## SERVICE BULLETIN

### KAIR12002 – Undercarriage Skypper and Tanarg

**SUBJECT:** Verification of condition of undercarriage tubes  $\varnothing 25 \times 1.2$  securing the connection rod bearing.

**Aircraft concerned:** Trikes Skypper and Tanarg according to serial number.

Dessin N°1 / Drawing N°1

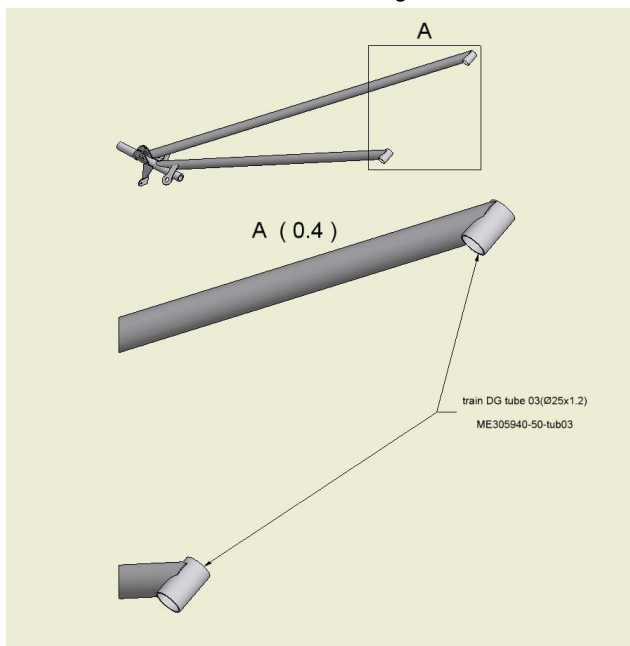
- Following a defective lot of tubes  $\varnothing 25 \times 1.2$  used only in the manufacture of soldered undercarriages for the Tanarg and Skypper, it is mandatory to check, on the listed trikes, the condition of the soldering of the cylinder at the end of the tubes, this on both of the tubes securing the connection rod bearing (drawing 1). If the welding inside the tube is uninterrupted, there is no problem (photo 1). If the welding is interrupted (photo 2), then the undercarriage must be replaced. In order to continue flying, during the time it takes to receive a replacement part, it is however possible to re-solder (TIG) inside the tube with more metal (photo 3). Finally, if the welding is interrupted, but the welding is maintained by the assembly welding of the main tubes, then it is not necessary to change the undercarriage (photo 4, where the welding is on the opposite side).
